September 15, 2010

Attn: Document Control Desk
Ron Linton
Project Manager
Uranium Recovery Licensing Branch
Division of Waste Management and
Environmental Protection
Office of Federal and State Materials and
Environmental Management Programs
U.S. Nuclear Regulatory Commission
Two White Flint North, MS T8F5
11545 Rockville Pike
Rockville, MD 20852

Re: Text Revisions to the Open Issues to the Safety Evaluation Report for the Nichols Ranch ISR
Project License Application (TAC J00553, Docket No 040-09067)

FIGURE D6B.6-1 BAROMETRIC PRESSURE AND WATER-LEVEL CHANGE IN A SAND PUMPING WELL, URZNA-9

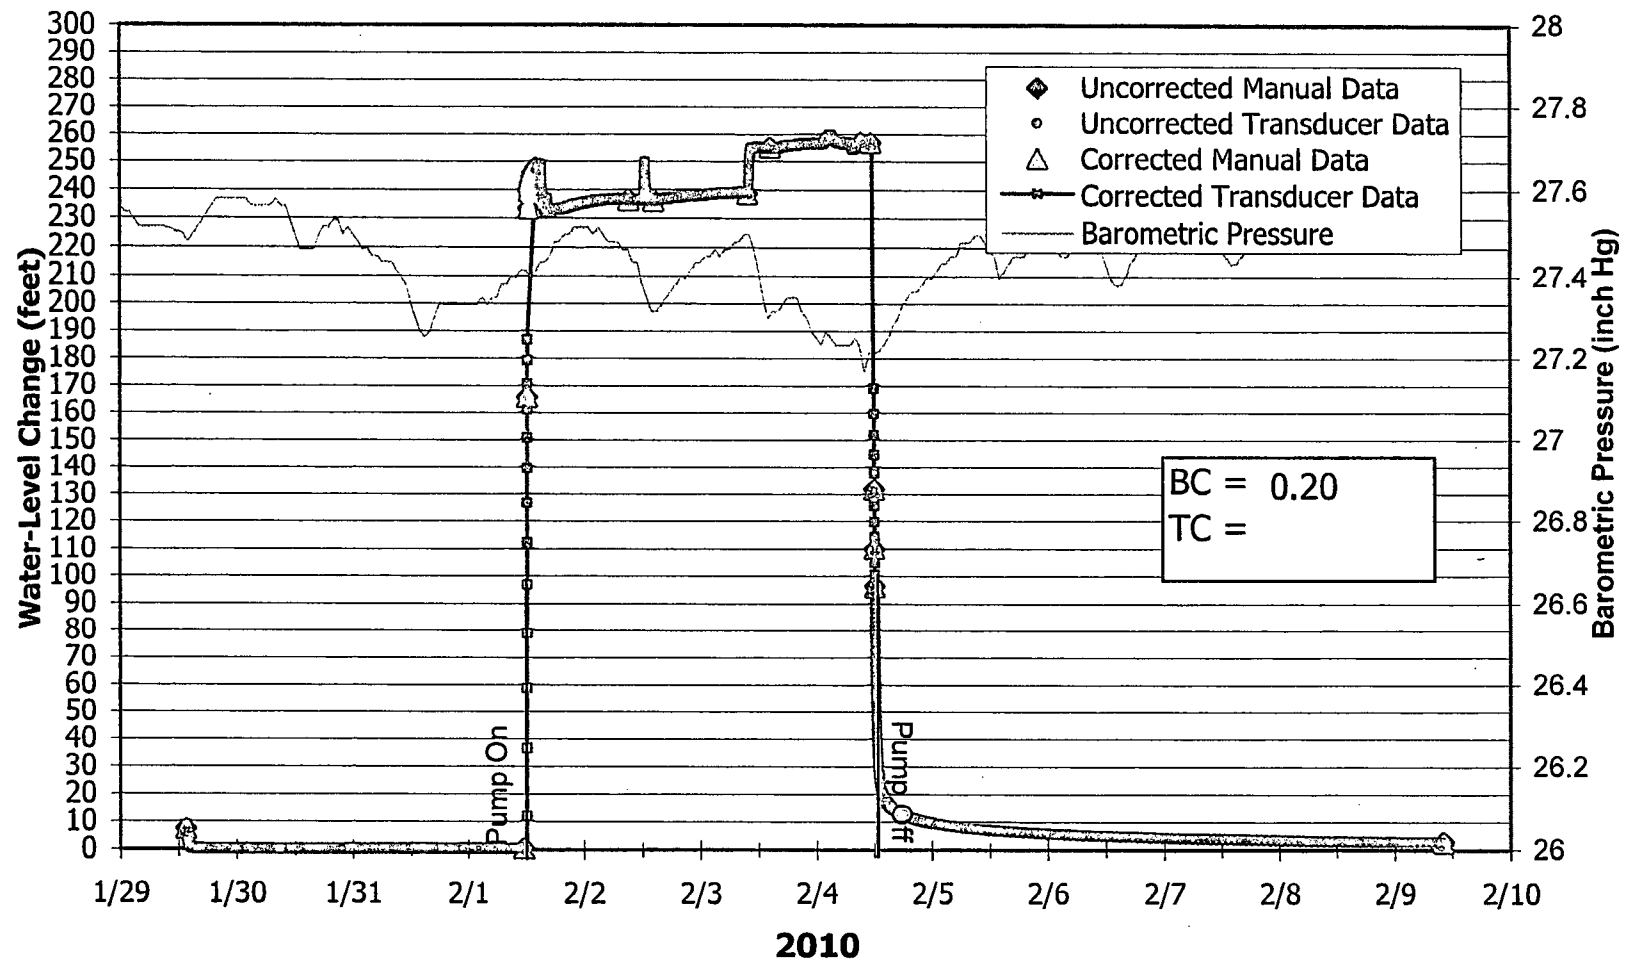
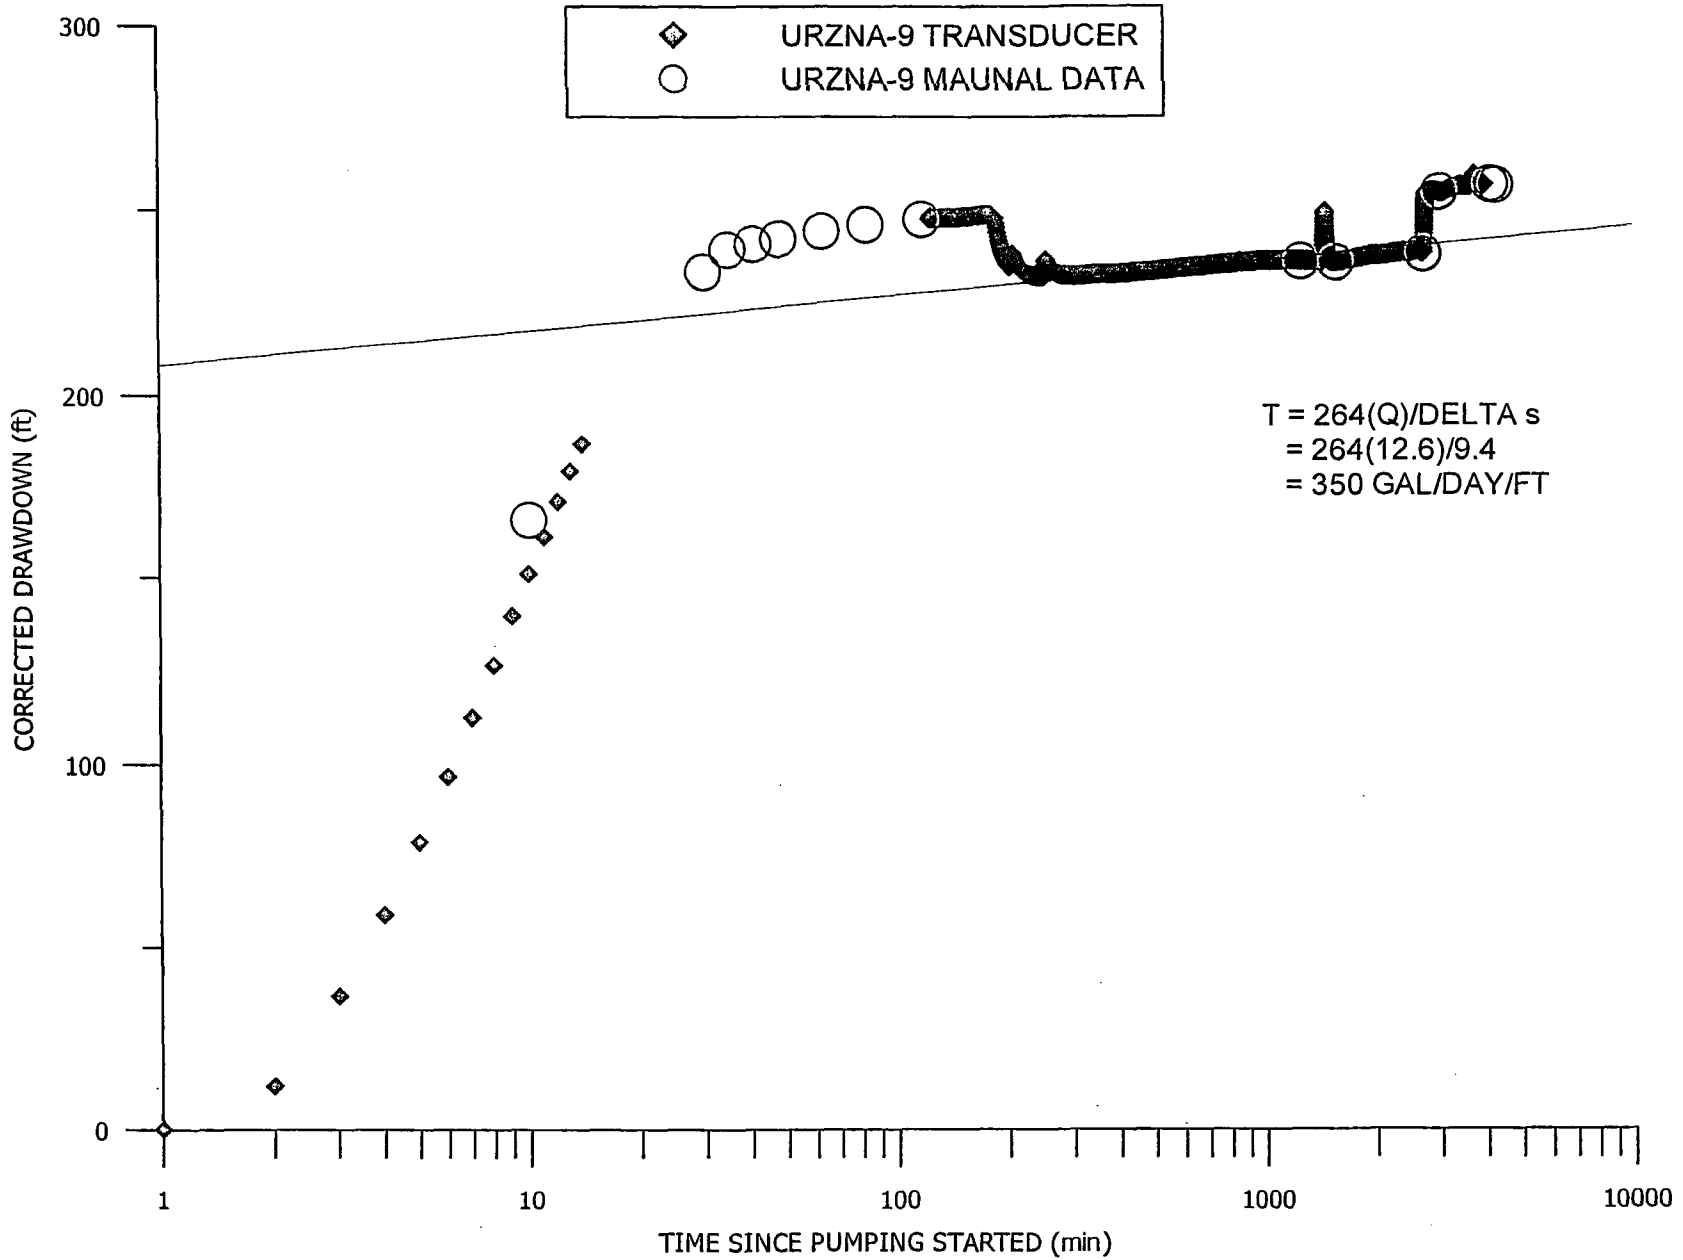
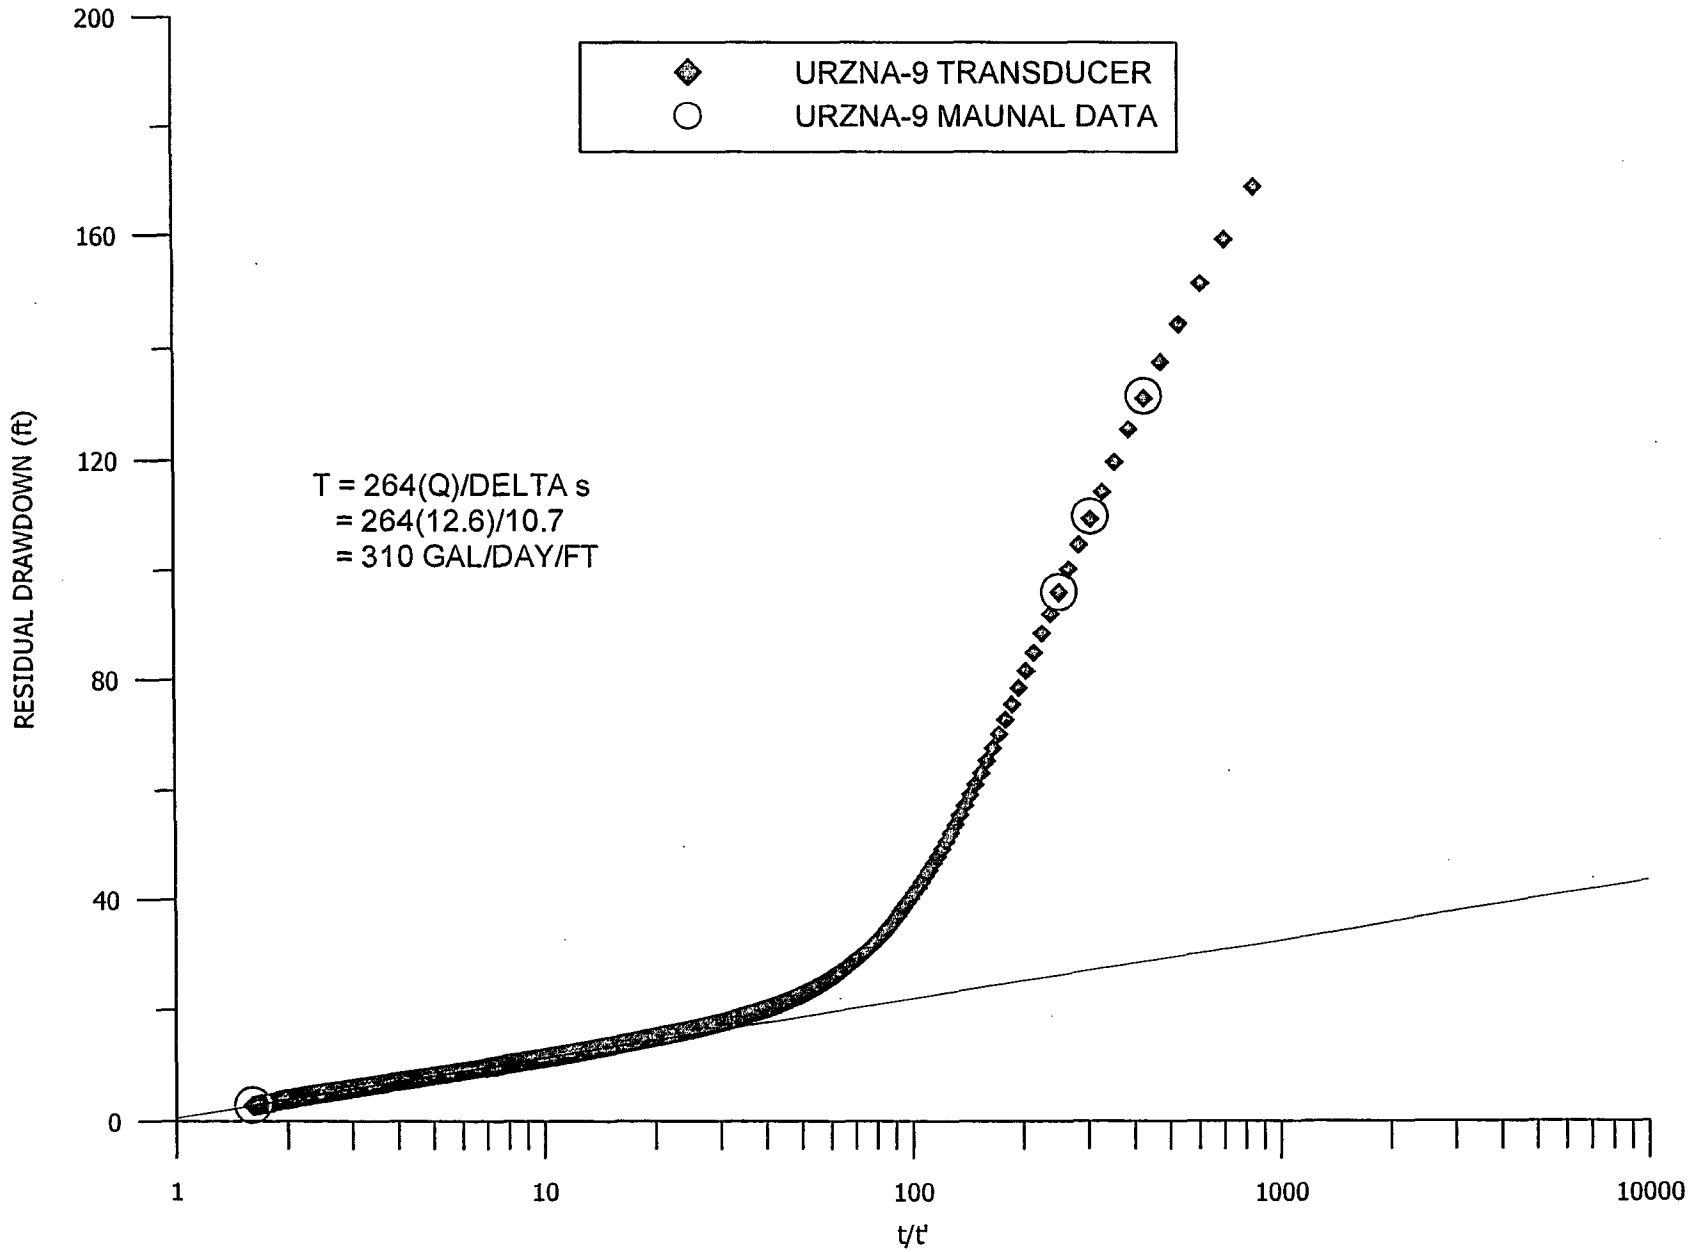
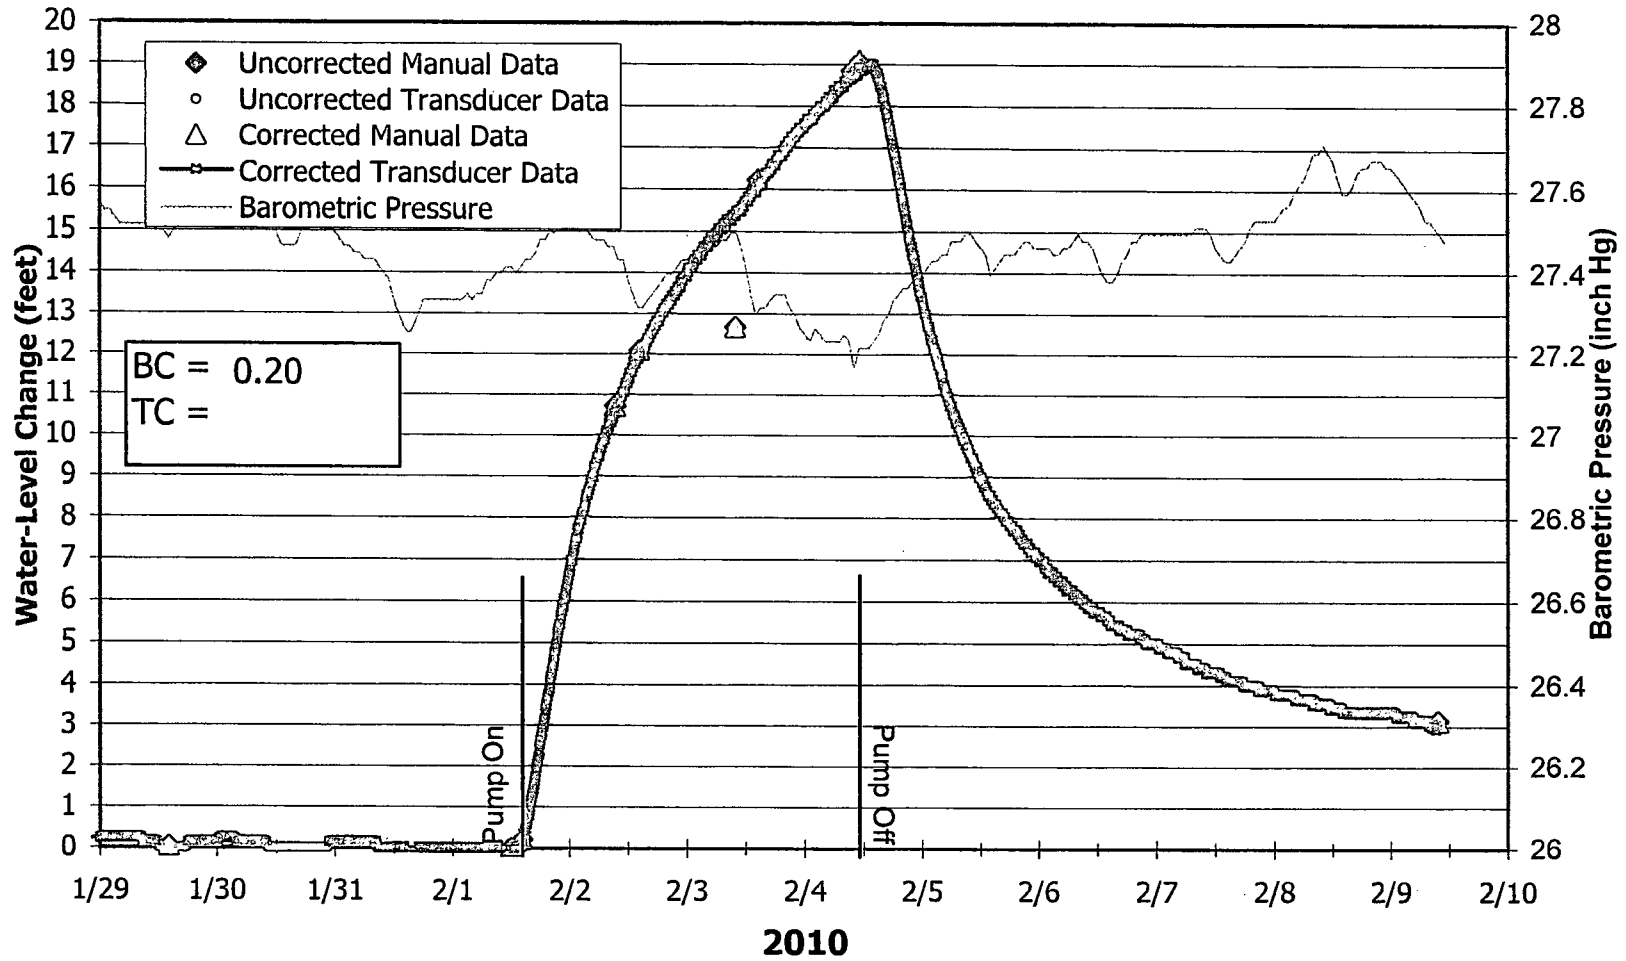
Volume VI, Appendix D6, Addendum D6B		Figures D6B.6-1 through D6B.6-13, April 2010, pgs D6B.6-4 through D6B.6-16	Figures added per Third Consolidated Review Comment 116-M.
Volume VI, Appendix D6, Addendum D6B		Tables D6B.6-1 through D6B.6-8, April 2010, pgs D6B.6-17 through D6B.6-42	Tables added per Third Consolidated Review Comment 116-M.
_____	_____	_____	_____
_____	_____	_____	_____
_____	_____	_____	_____
